BRUNSWICK STEAM ELECTRIC PLANT, UNIT NO. 2

AMENDMENT TO FACILITY OPERATING LICENSE

Amendment No. 38  
License No. DPR-62

ATTACHMENT TO LICENSE AMENDMENT NO. 38

MAXIMUM AVERAGE PLANAR LINEAR HEAT  
GENERATION RATE (MWPLHGR)  
VERSUS PLANAR AVERAGE EXPOSURE  
FIGURE 3.2-1b

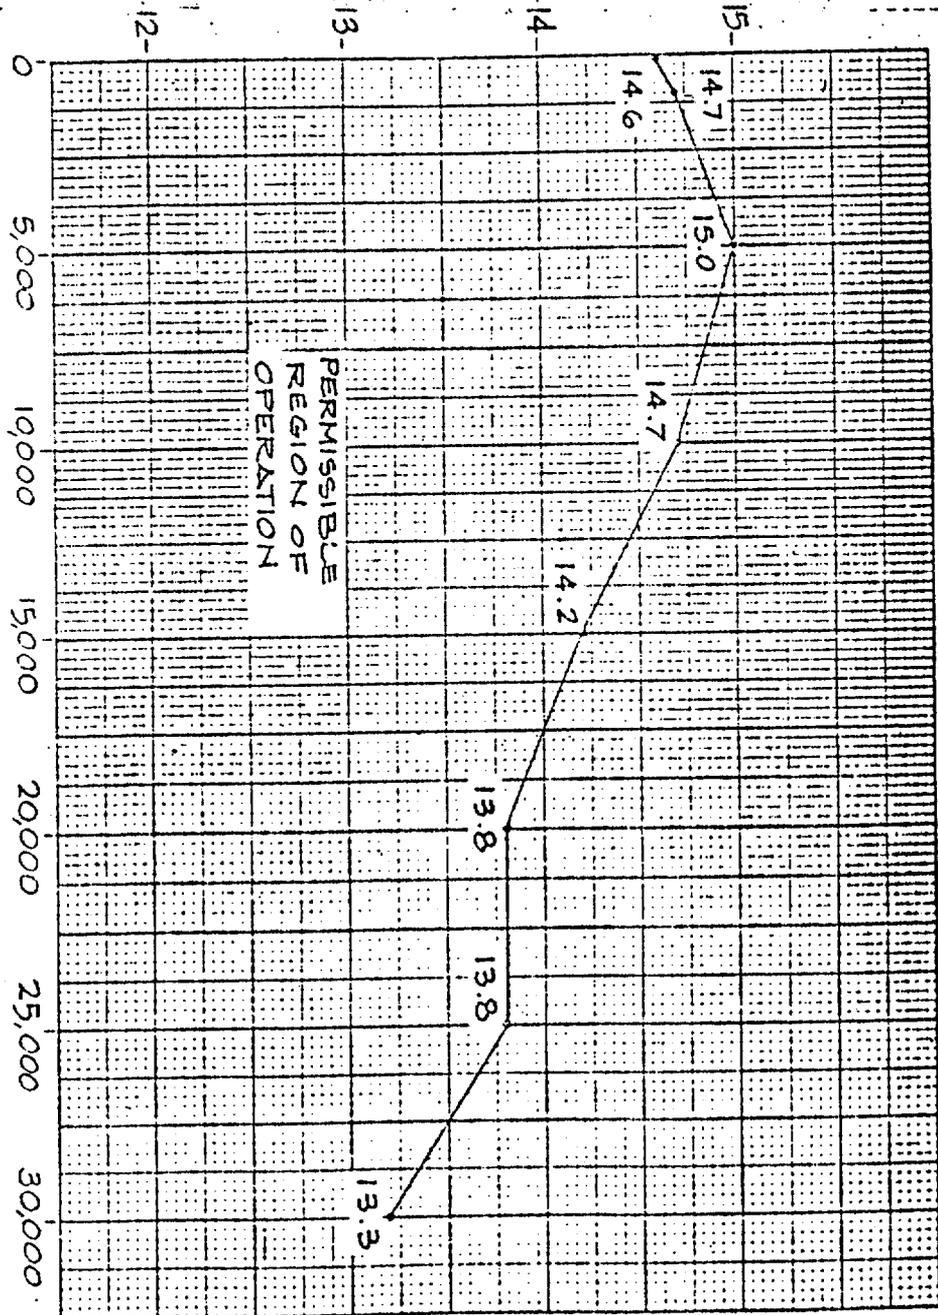
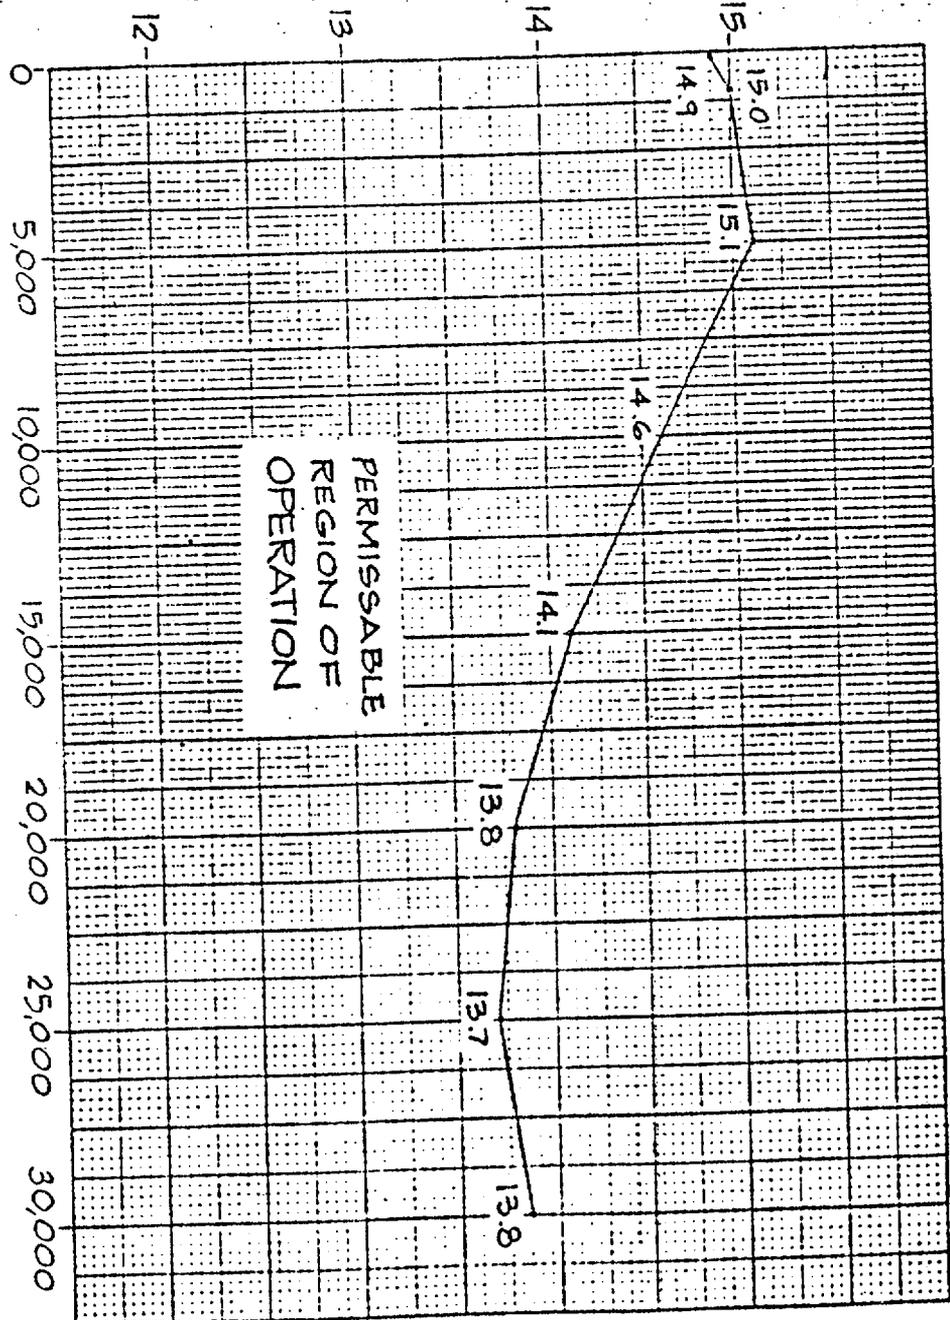
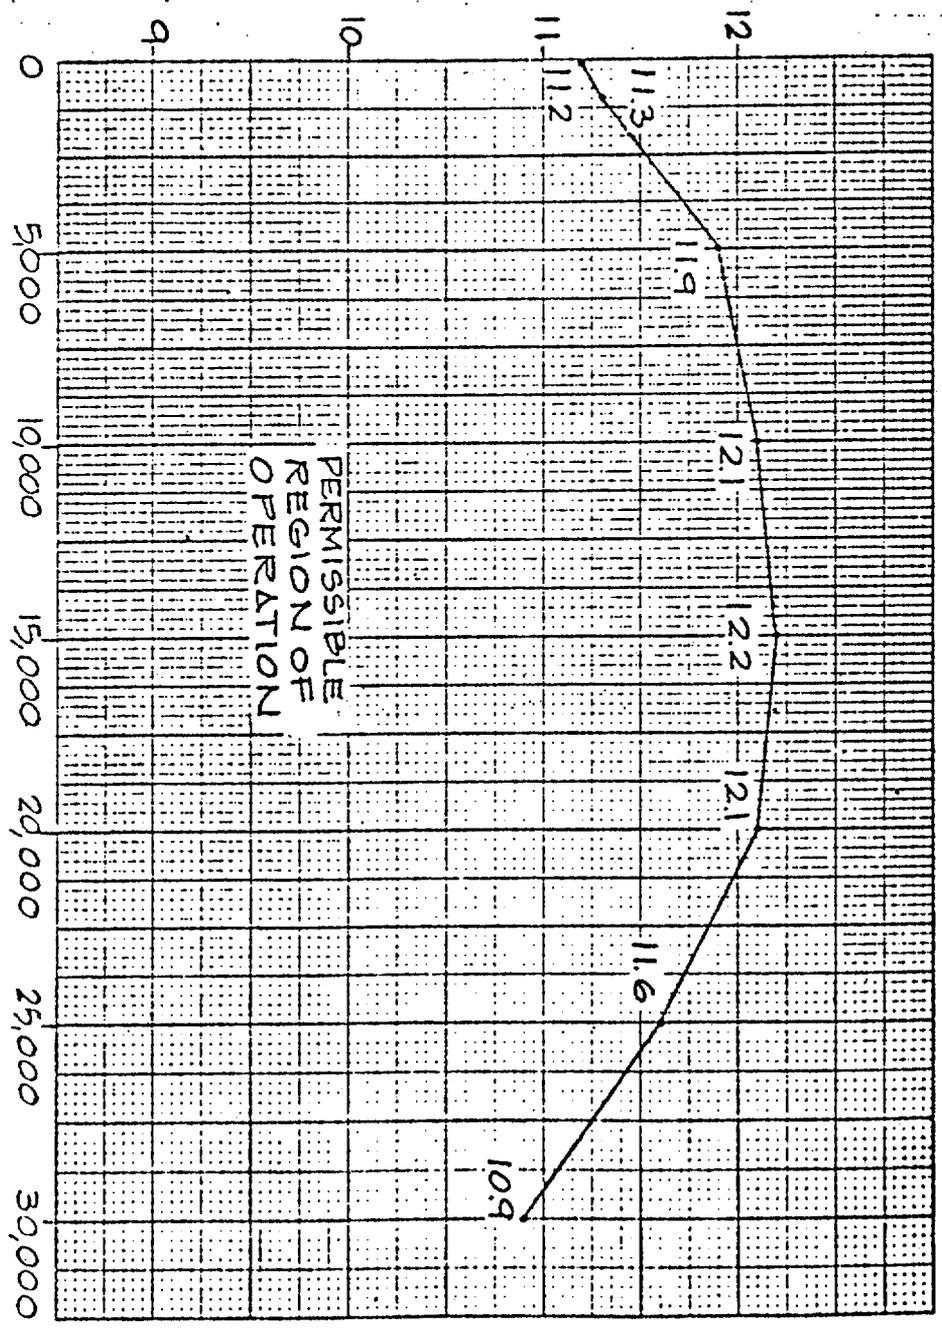
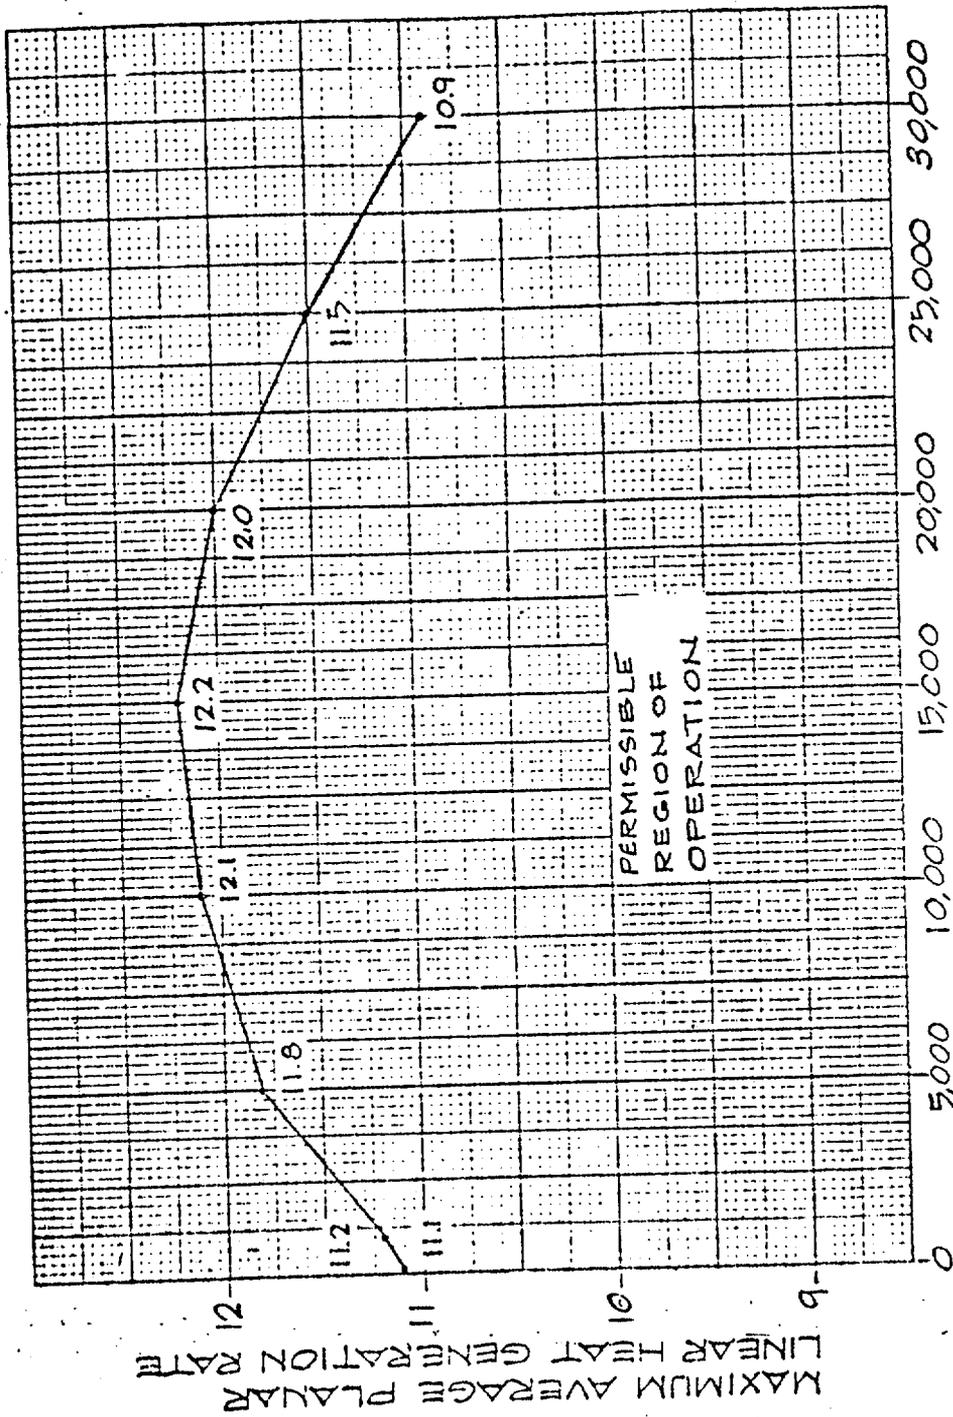
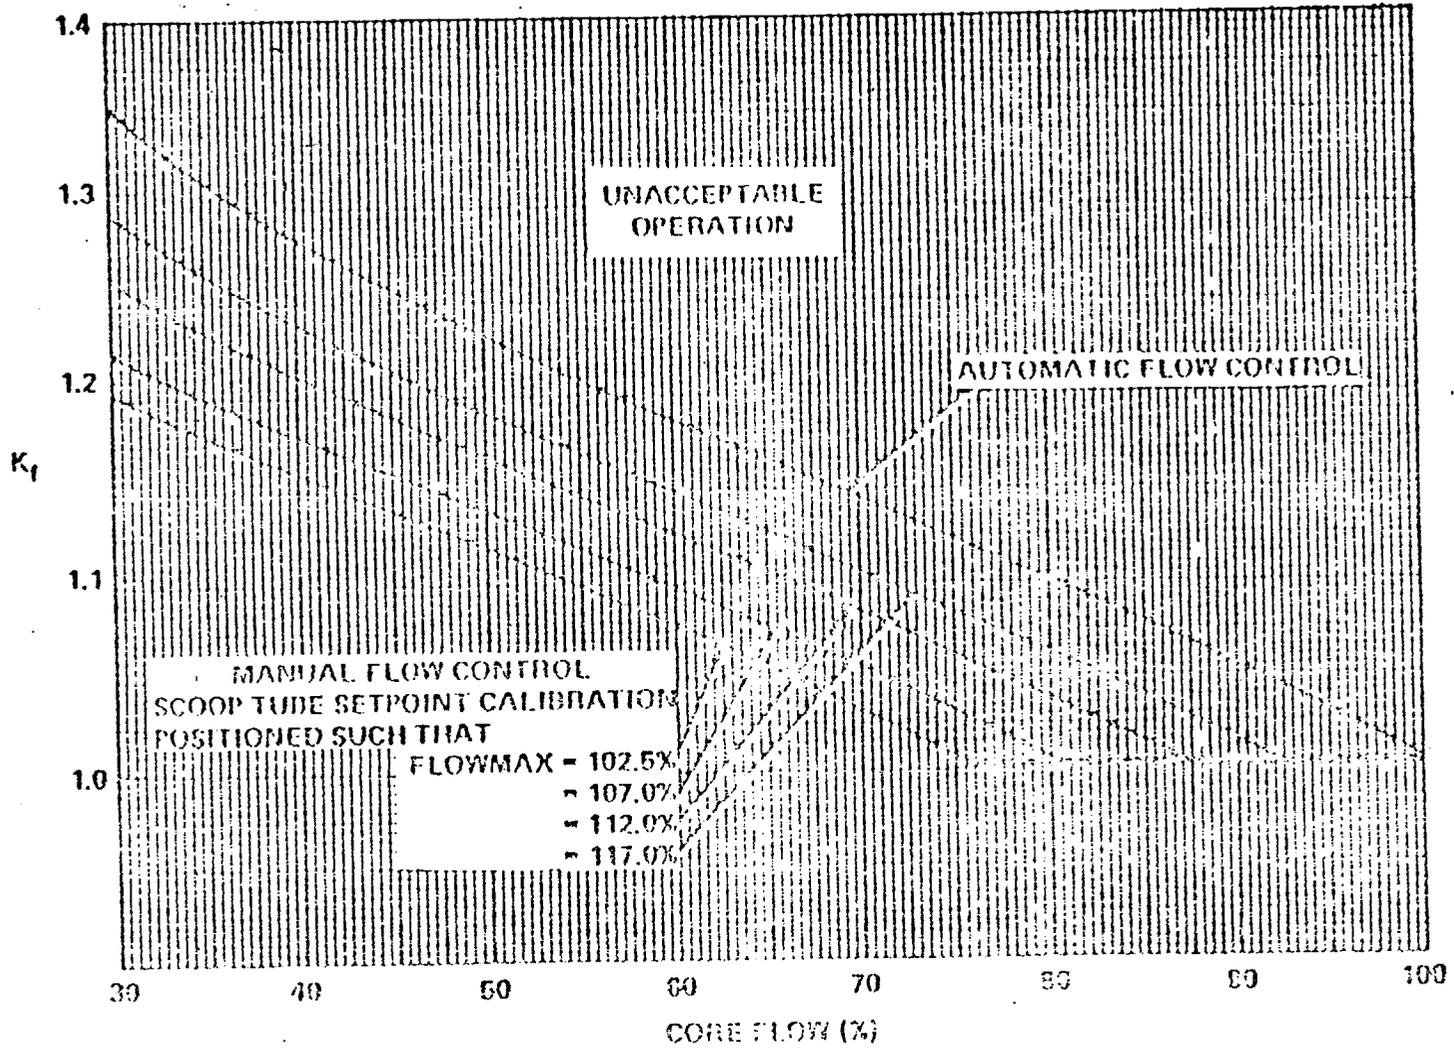
During steady state power operation\*, the APLHGR for each type of fuel as a function of average planar exposure shall not exceed the limiting value shown in Figures 3.2-1a through e.

Figure 3.1-1

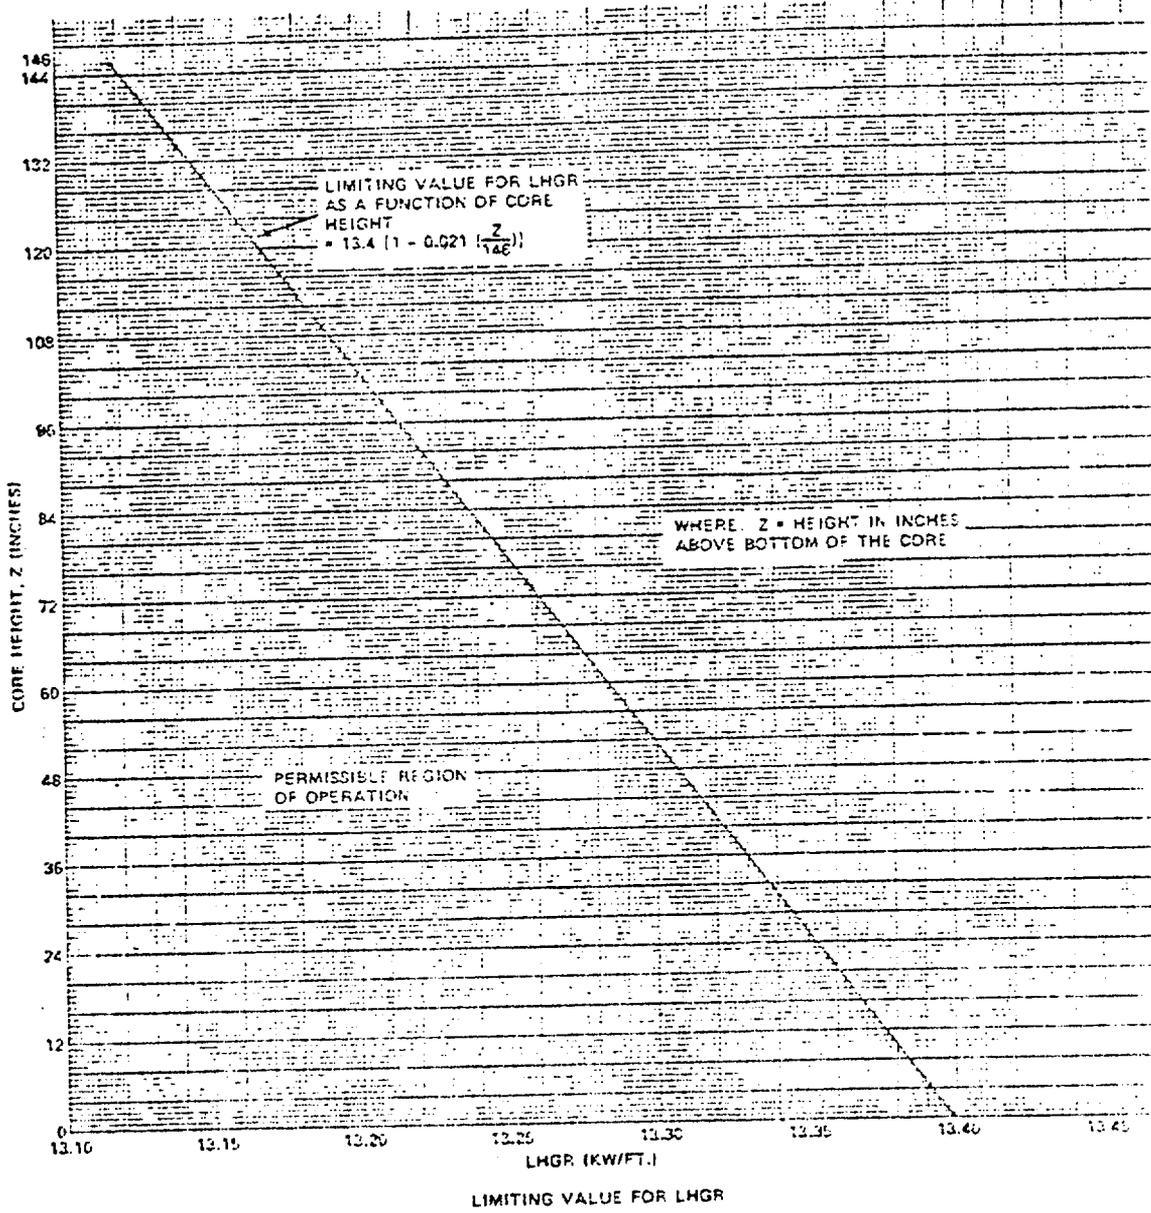
During steady-state power operation (25% or greater), MCPR as a function of core flow shall be equal to or greater than MCPR x the  $K_f$  shown in Figure 3.1-1, where:

The minimum MCPR values for less than full rated flow are equal to the MCPR for full rated flow multiplied by the respective Kf factor values appearing in Figure 3.1-1 of the Technical Specifications.

$$\text{MCPR (7x7)} = 1.26$$

$$\text{MCPR (8x8)} = 1.30$$

Figure 3.1-2B  
 Amendment No. 38

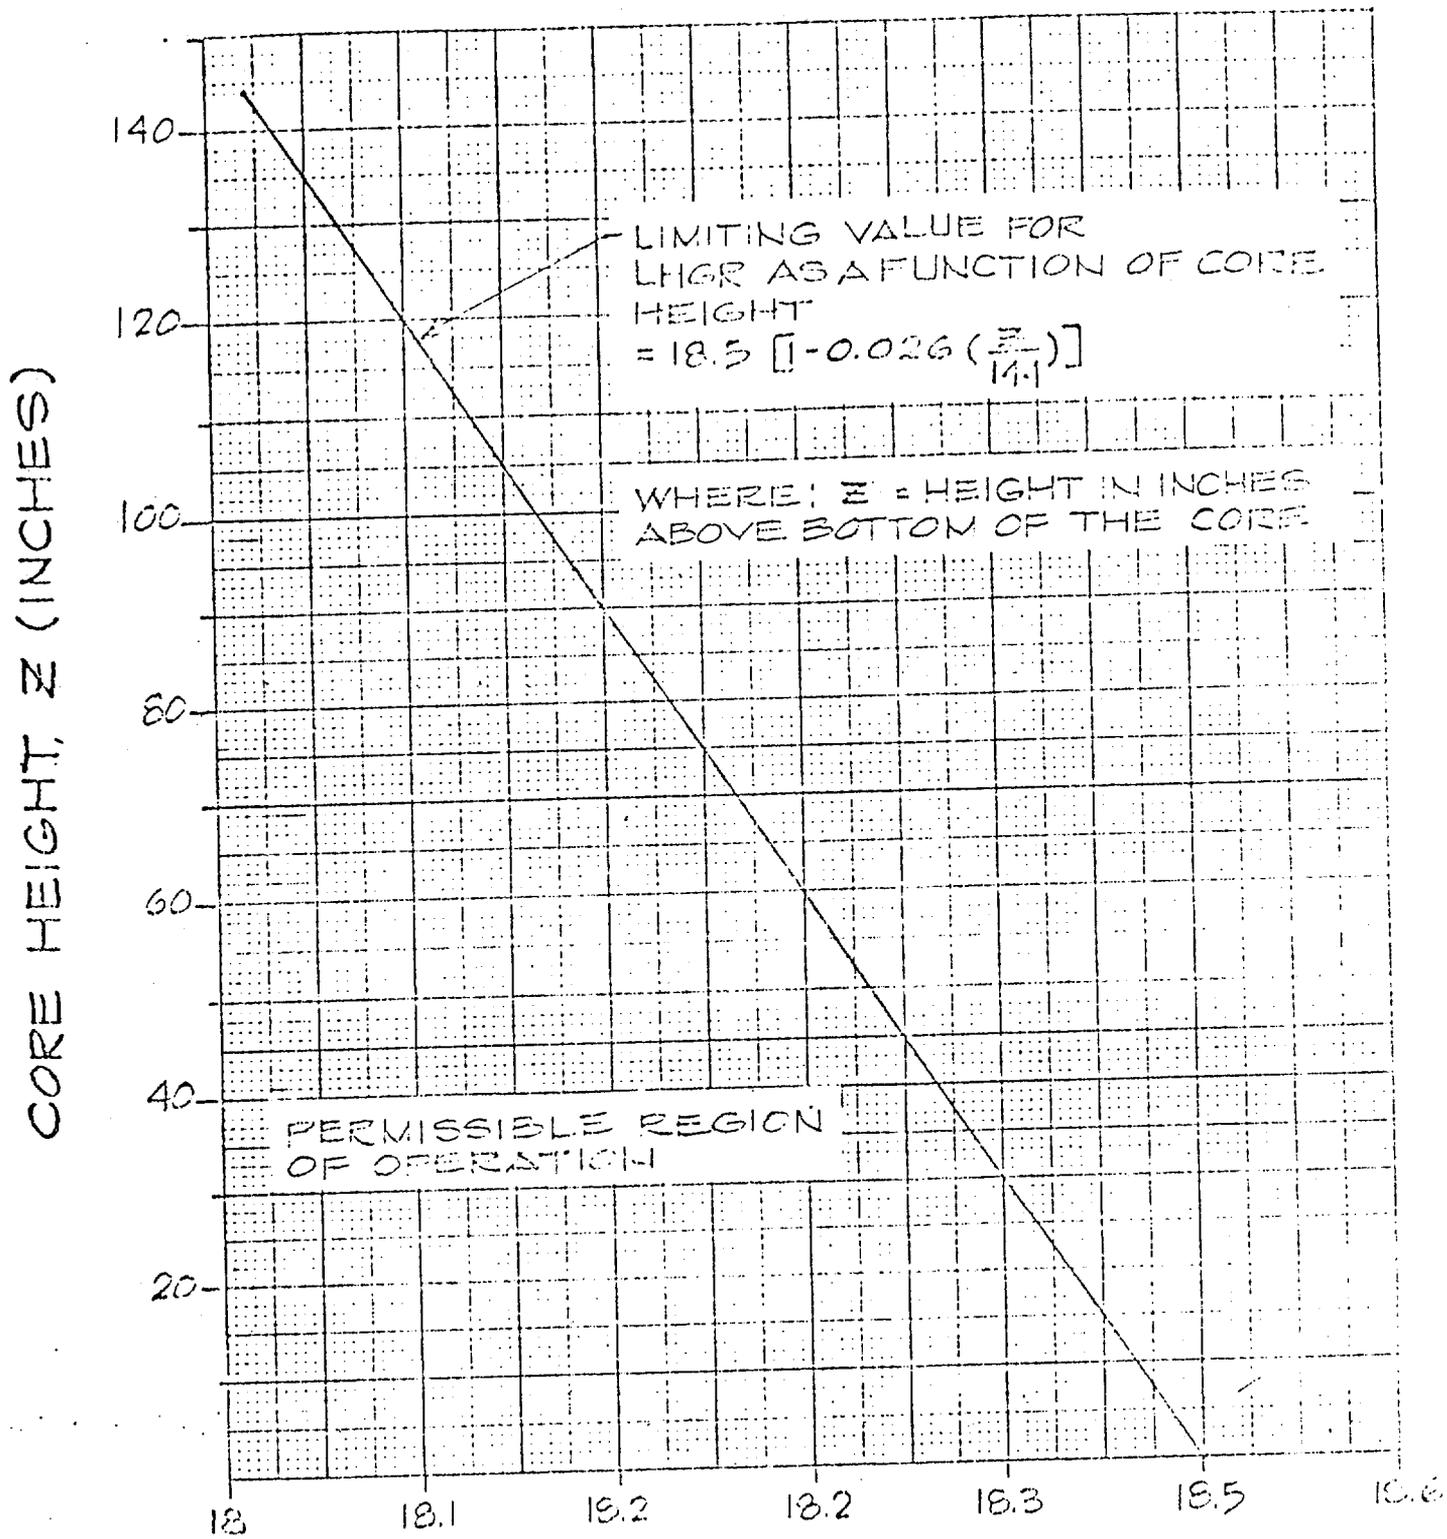
During steady-state power operation (25% power or greater), all linear heat generation rates (LHGRs) as a function of core height for any fuel rod in an assembly shall not exceed the applicable maximum LHGR shown in Figures 3.1-2a and b.
